PERMIT

SEWAGE DISPOSAL SYSTEM

HOWARD COUNTY HEALTH DEPARTMENT

SUBDIVISION Locust Ridge/ Belsinger Property LOT 9 ROAD 3803 Folly Quarter Road

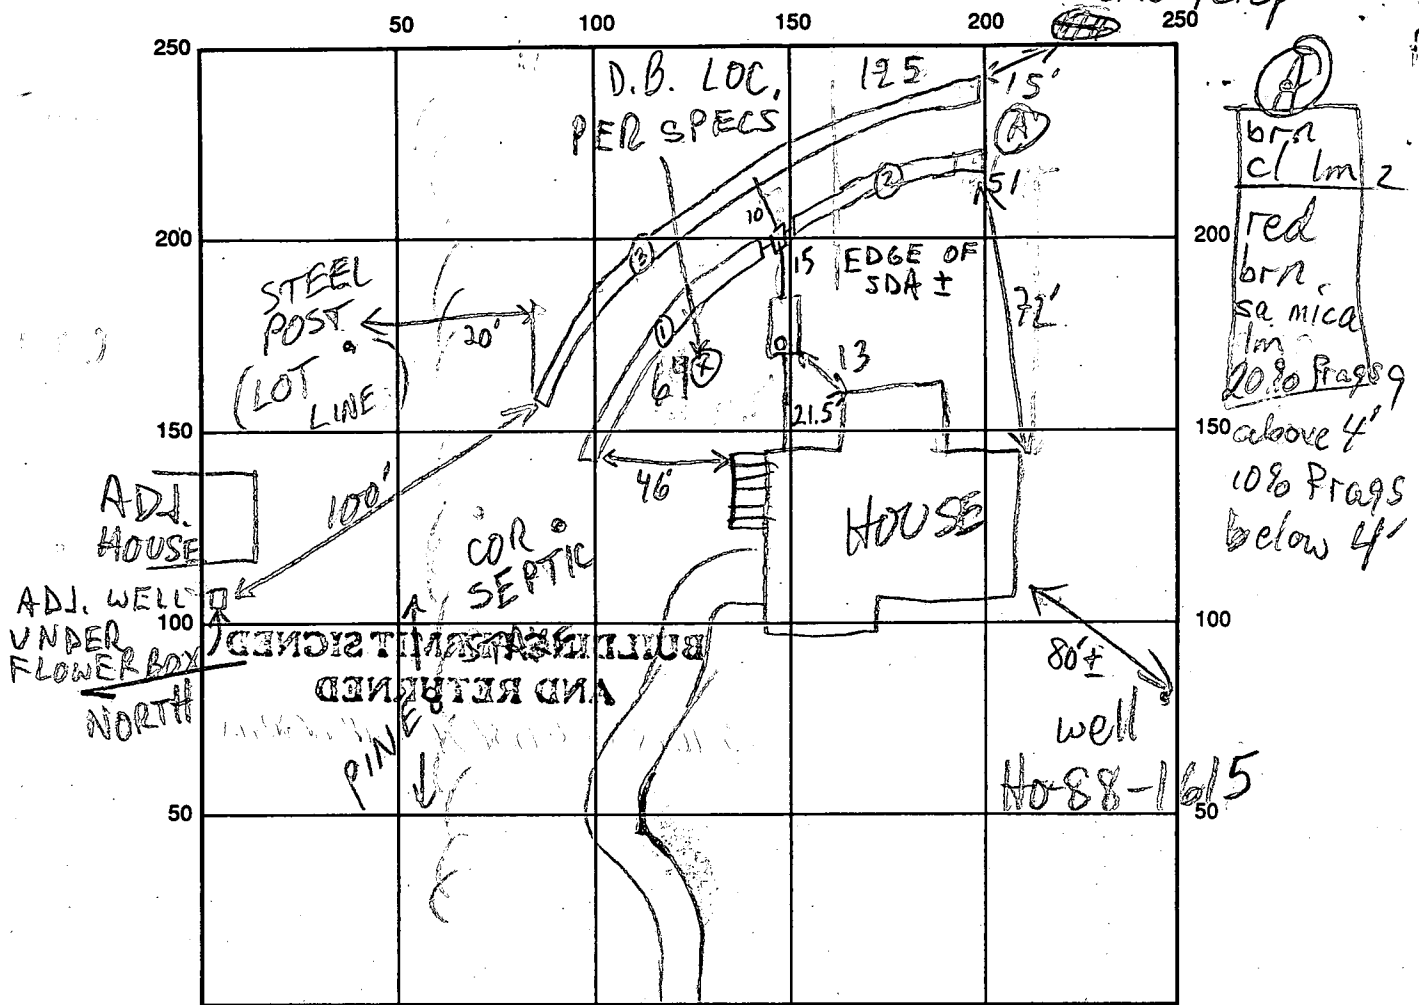
REMARKS: 4/8/96 D.B. LOC. OFF ~30-35' (13' L/R, 20' DOWNHILL)°

AGREED TO CONSIDER INSTALLED TRENCHES W/CONF. HOLE°

ALSO NEED 25' ADDED TO NORTHERN ENDS OF BOTH TRENCHES MR

4/11/96 TRENCHES EXTENDED - OK; ONE REPAIR TRENCH LOC.

AVAIL ABOVE TRENCH @; OK TO COVER MR

4/8/96 W.P.I OK TO COVER 3 1/2 B.G. MR

SITE PLAN
SCALE 1" = 30'

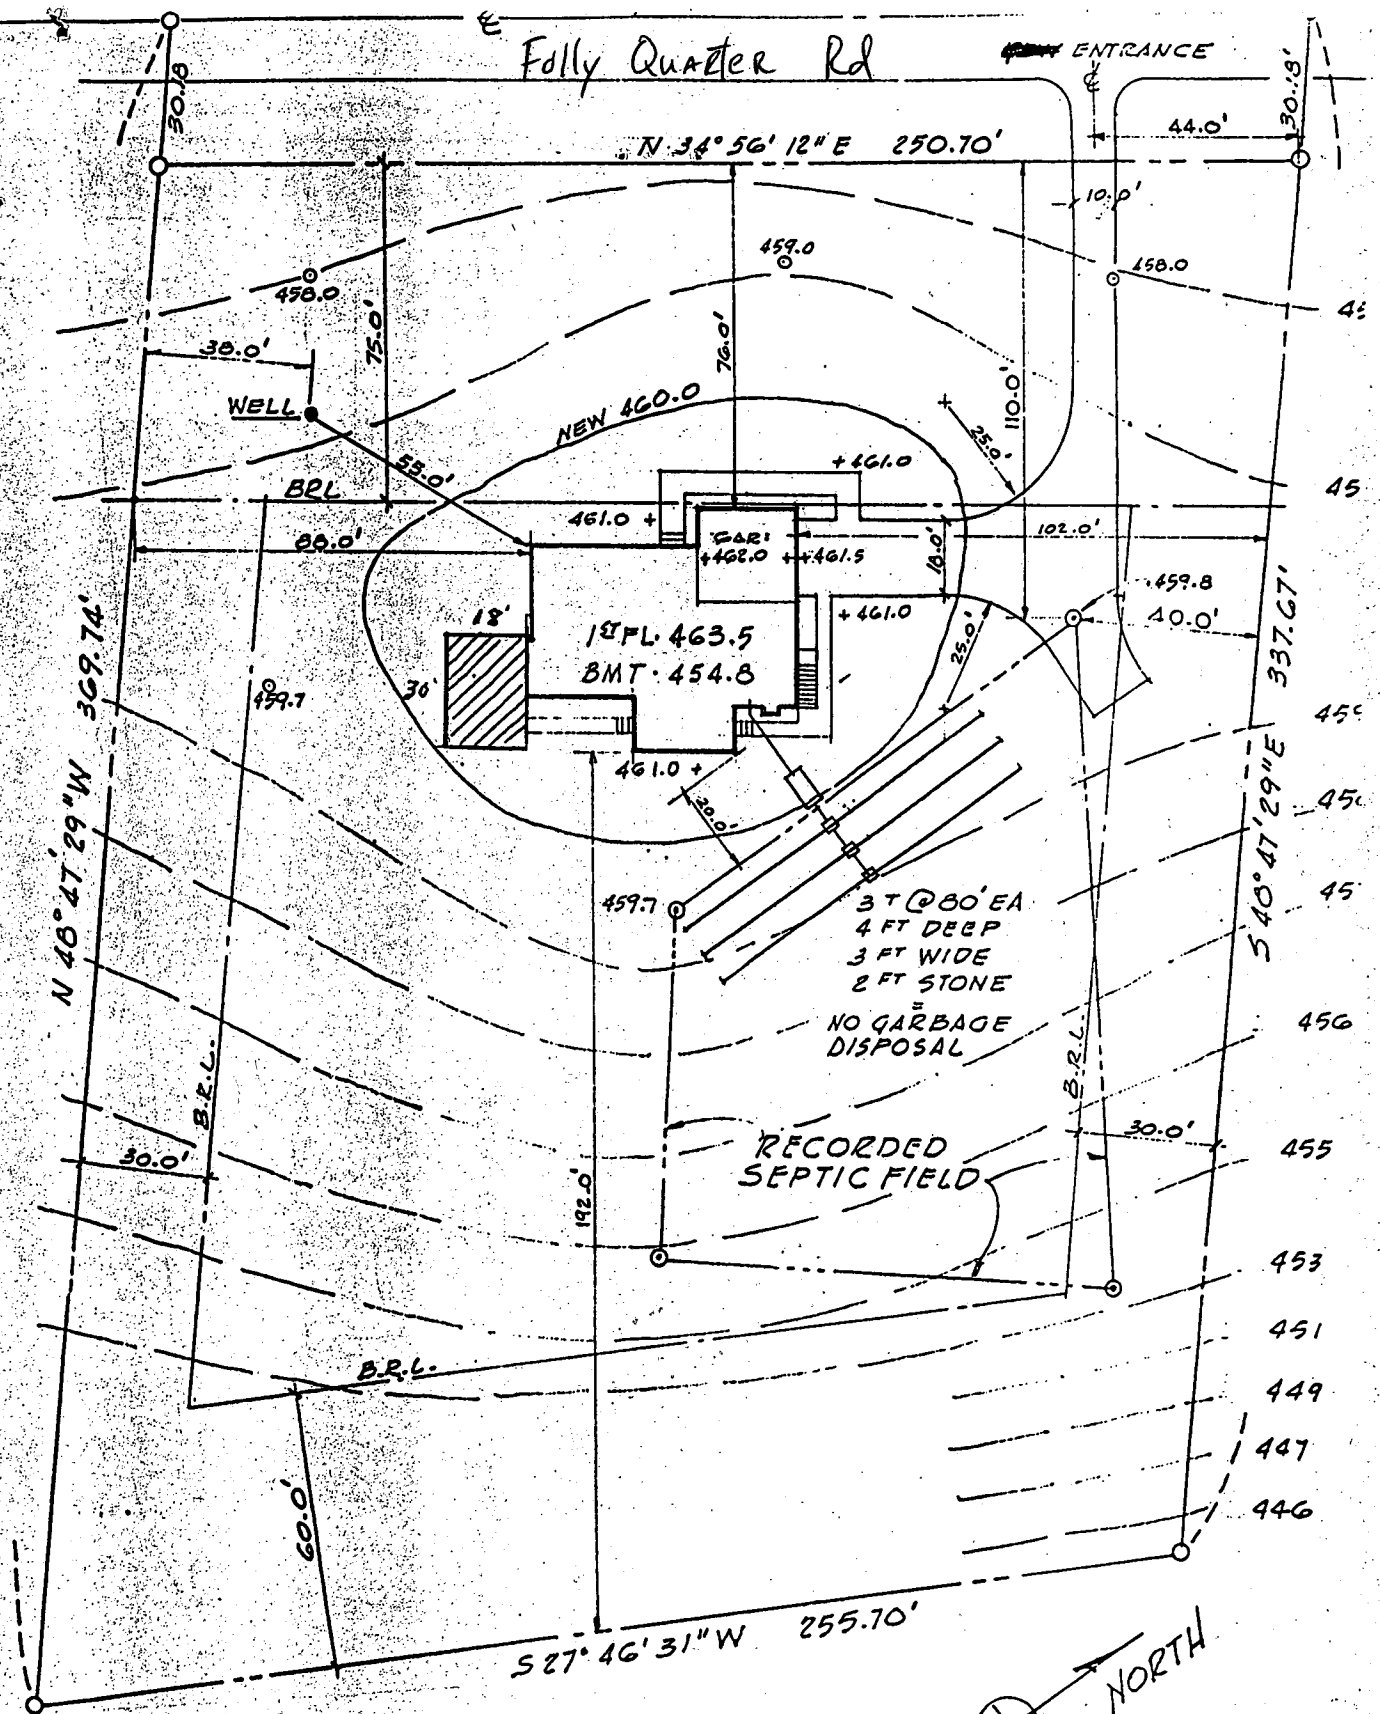
5/10/05
B0015362
ENOUGH TRENCH
CAPACITY
FOR FIVE BEDROOM
TANK IS 1250'
SHOULD BE
1500 GAL.
NEWIS
SYS.

Will not
allow
15
owner
confirm
to
bedrms
total
(KN)
